ADDENDUM NO. 2

November 2, 2021

CROWN POINT HIGH SCHOOL ADDITIONS AND RENOVATIONS **Crown Point, IN 46307**

This Addendum consists of Pages ADD 2-1 through ADD 2-2 and attached Addendum No. 2 from Gibraltar Design dated October 29, 2021 and consisting of 12 pages, Specification Section 04 01 00 - Masonry Cleaning, Specification Section 12 25 00 - Roller Shades, and 134 drawings.

DRAWING
A
SHEET
S-201

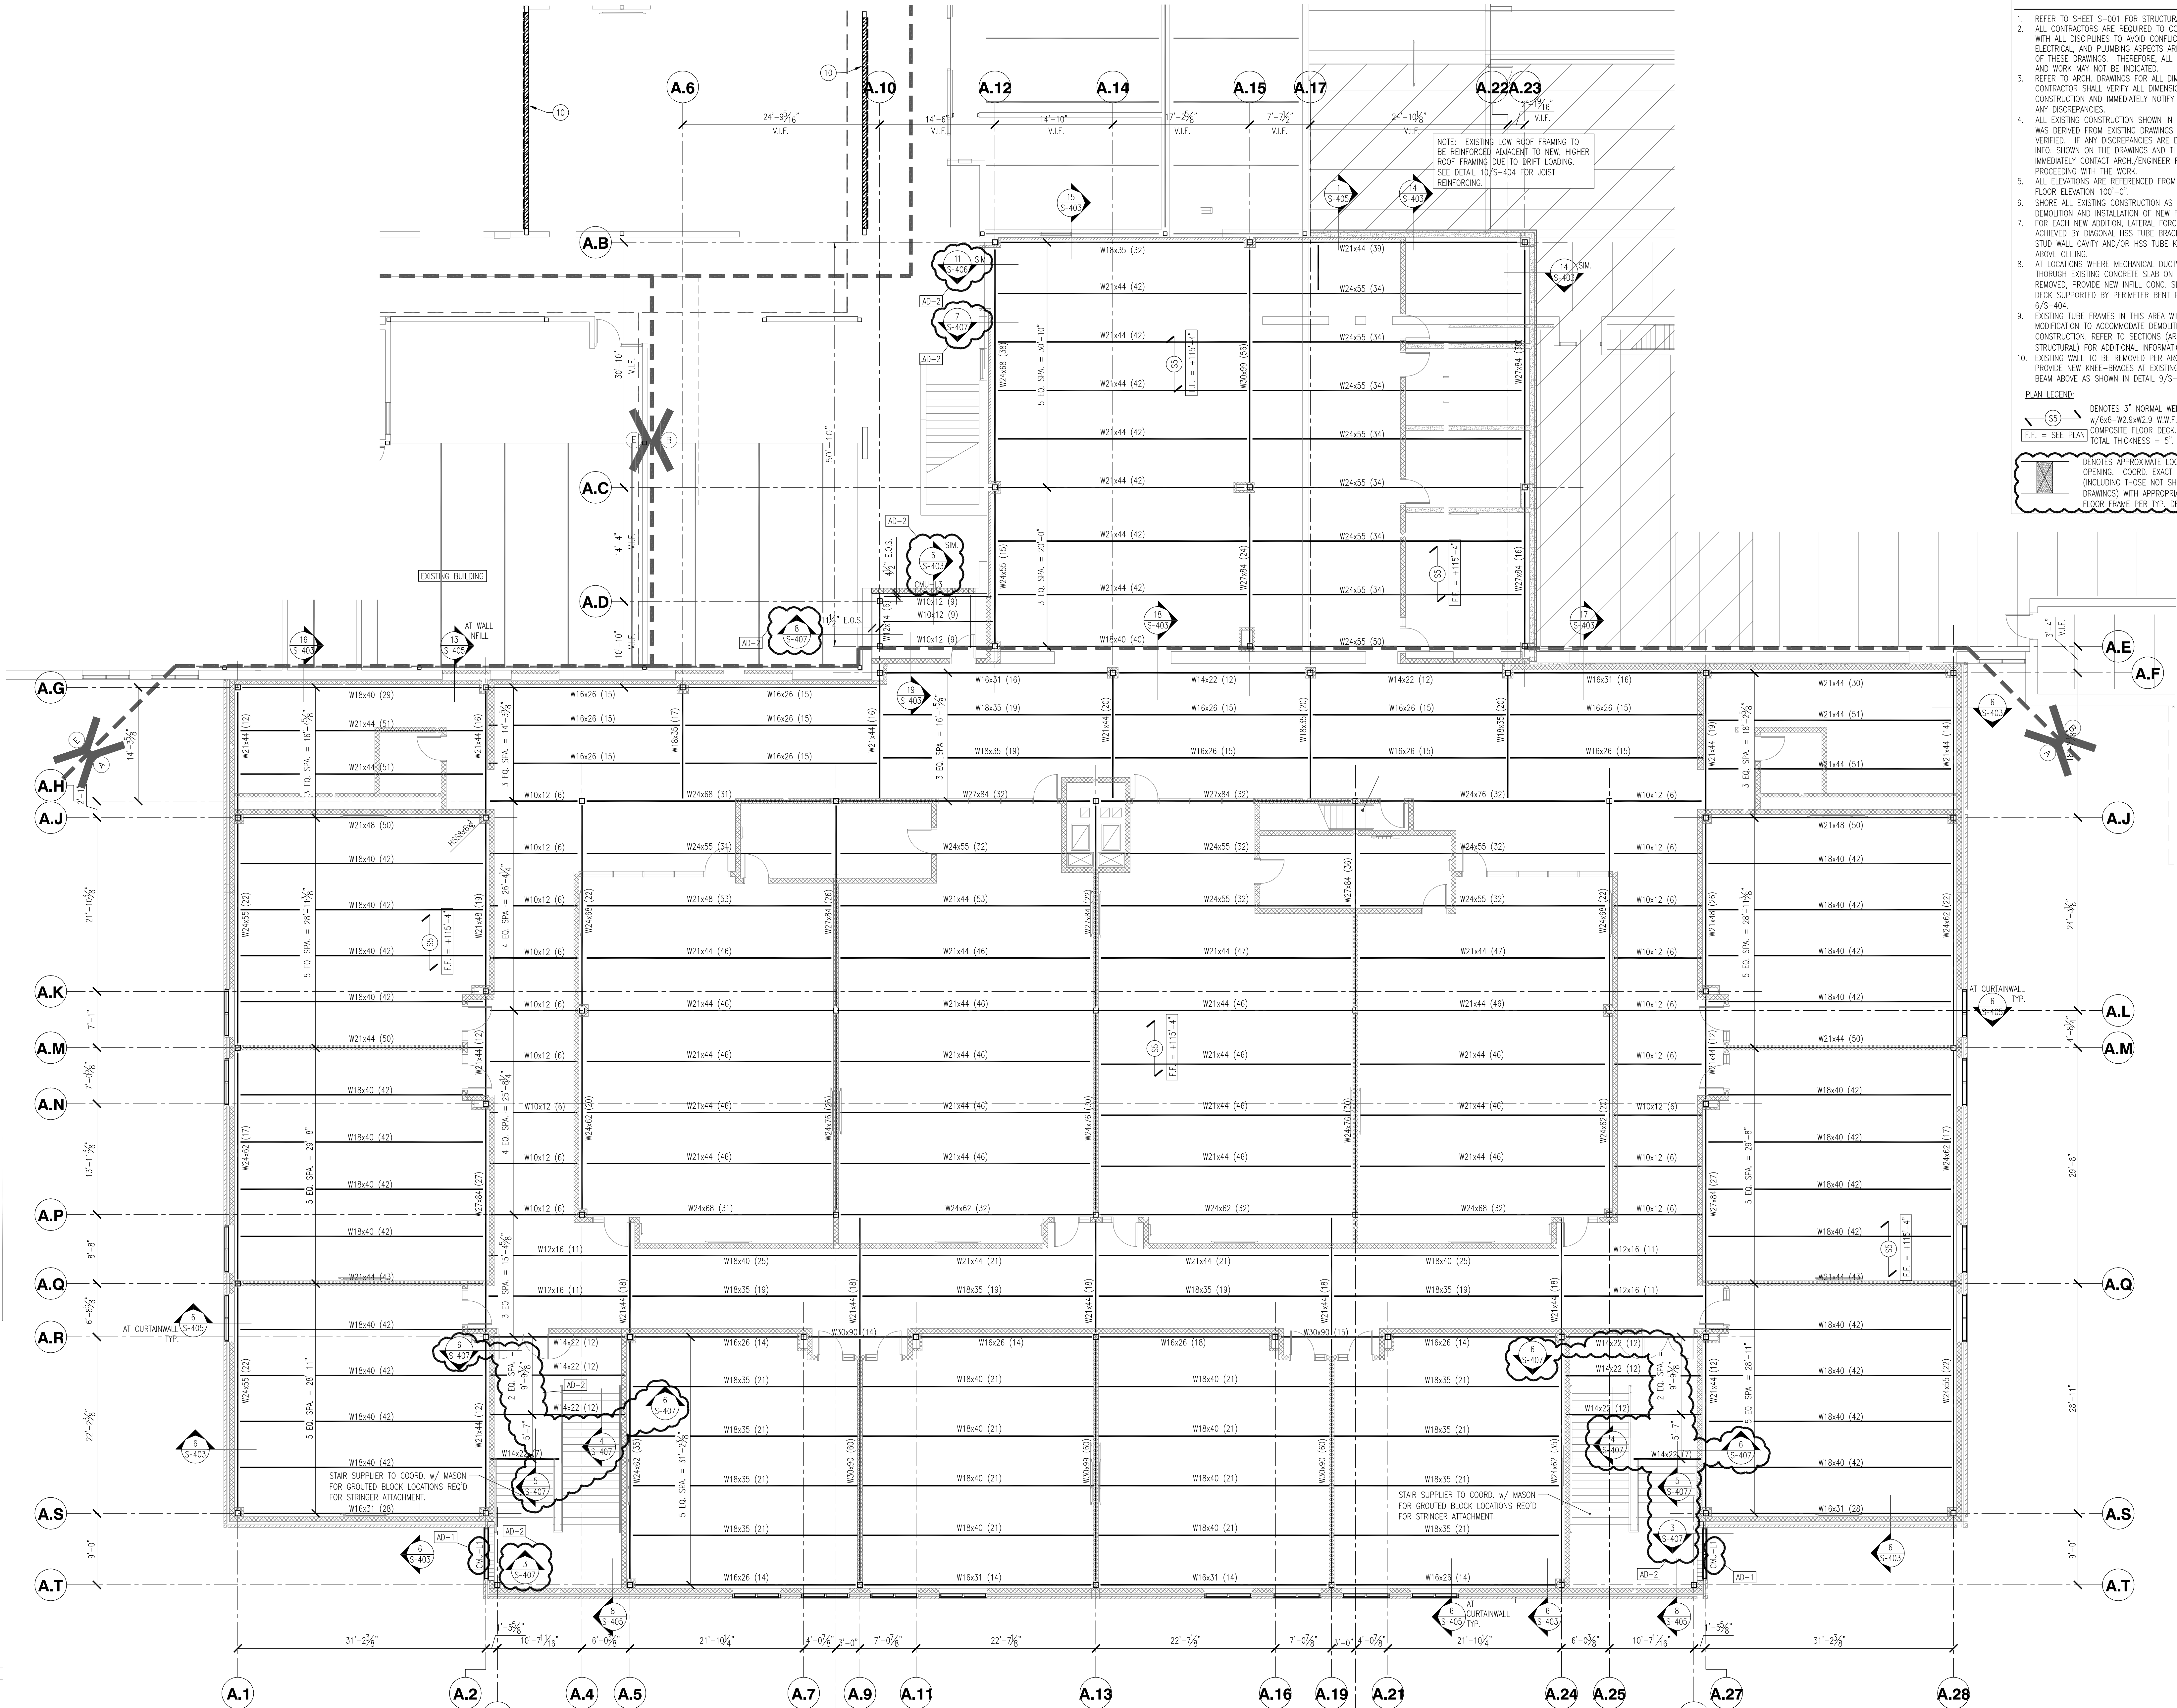
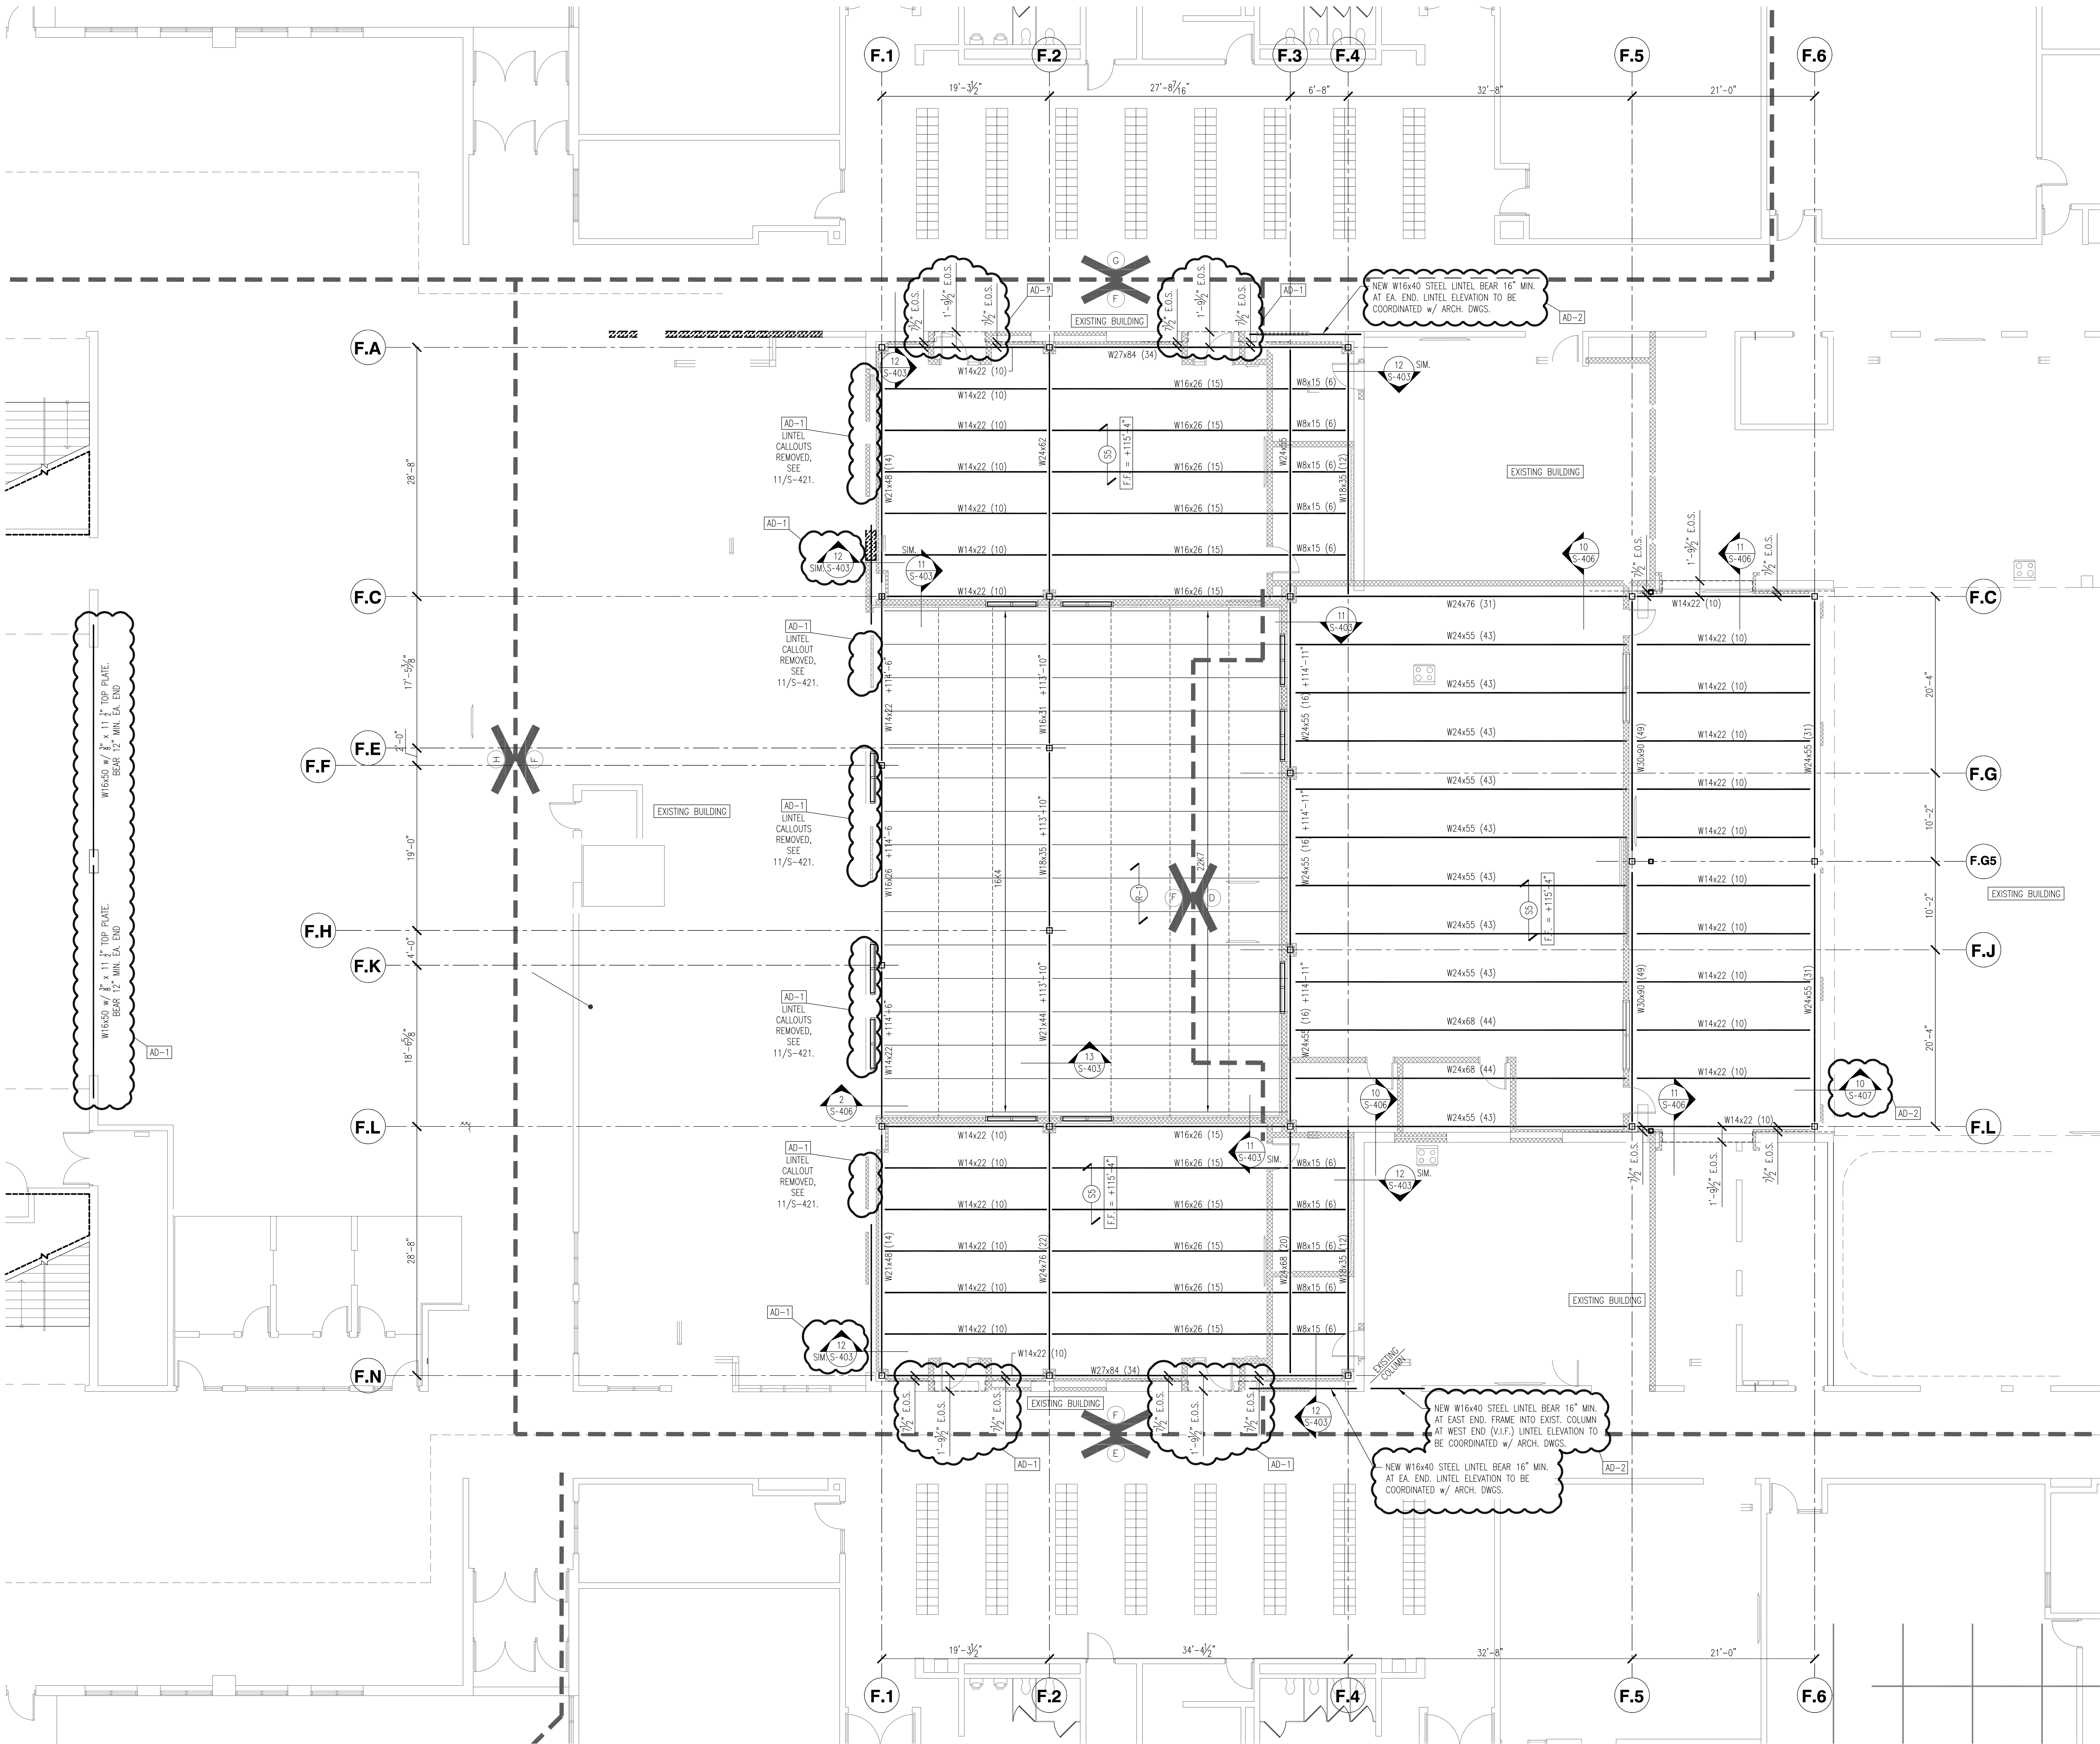
18. Sheet S-501

DRAWING
A
SHEET
A-101

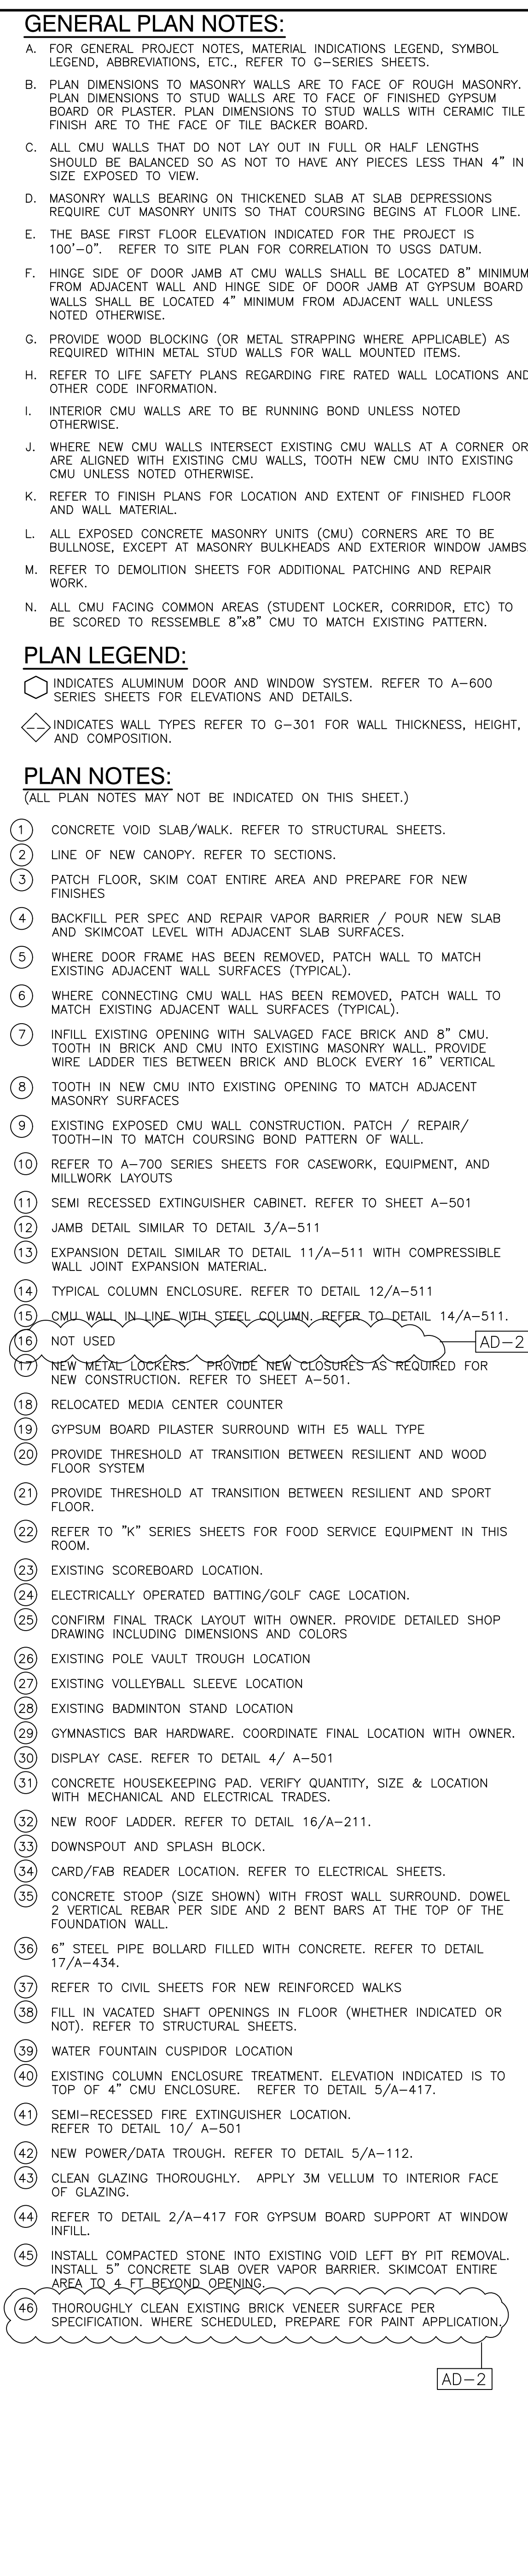
23. Sheet A-101
